Issued March 26, 2015

**RE: University of South Carolina  
Soccer Practice Fields Drainage Improvements  
State Project No. H27-Z204  
CHA Project No. 29614**

## **ADDENDUM NO. 2**

1. Lateral Pipe:

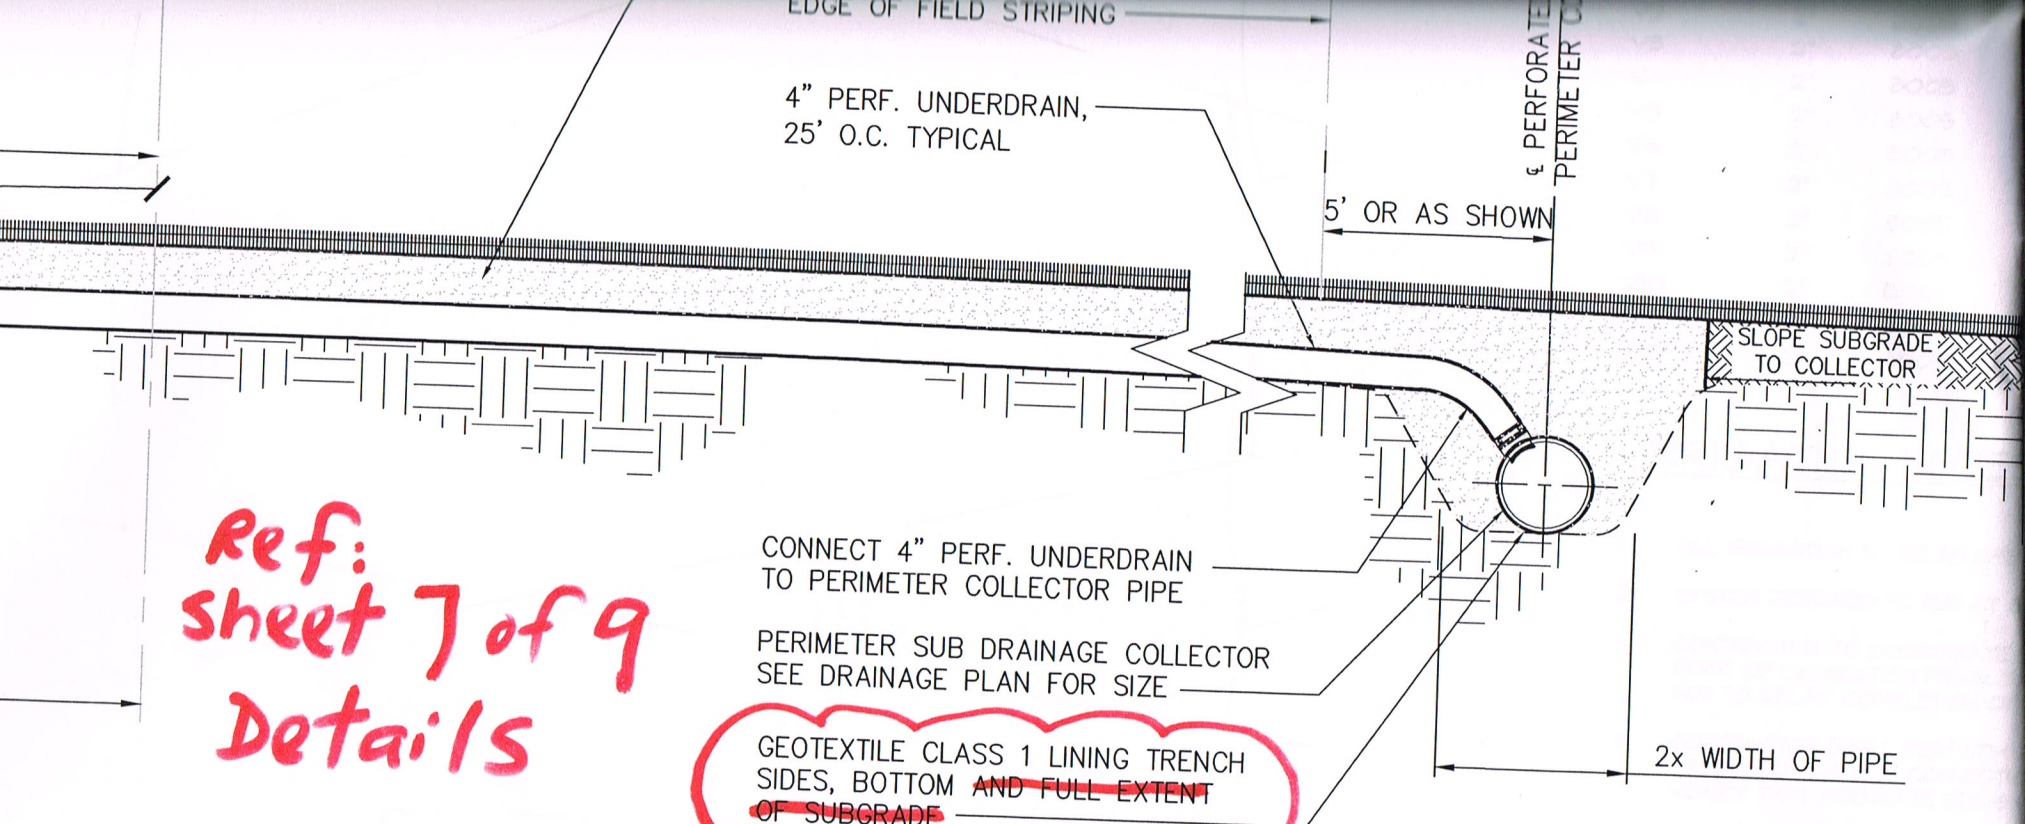
3. QUESTION: Section 321801 page 12 Drainage System Materials spec is not the same as Section 334100 page 2 HDP Soil Tight Pipe. Please clarify. ANSWER: The pipe specification in Section 321801 shall not be used. See specification revision below. As clarified in Addendum 1, Section 334100 shall be used for the "solid" drainage pipe shown on the plans as "header pipe" and Section 334100-20 shall be used for the perforated underdrain piping under the fields.

1. Reference SE-310 Invitation for Construction Services: Add Clarissa Clark’s name under the section for Bid Delivery Addresses. See attached markup.
2. Reference 321801 Natural Grass Playing Field System:
  - a. DELETE section 2.2.A.1.a that refers to single wall HDPE pipe. See attached marked up specification.
  - b. DELETE the words “playing field subgrade and” in section 2.2.C.1.a. See attached marked up specification.

- a. ~~4" HDPE, corrugated, single wall, perforated pipe meeting the requirements of AASHTO M252, Type "C" or "CP"~~
- b. Joints shall be made with split or snap couplings. Standard connections shall meet the soil tightness requirements of AASHTO M252 or M294.
- c. Perforations: Pipe shall meet AASHTO perforation requirements. Pipe shall have 1 square inch of perforated opening per linear foot of pipe. Perforations shall be slots with a max width of .12" and max length of .875". The perforations shall occur in each valley of the corrugations and there shall be 3 in each valley at 120 degree separations.
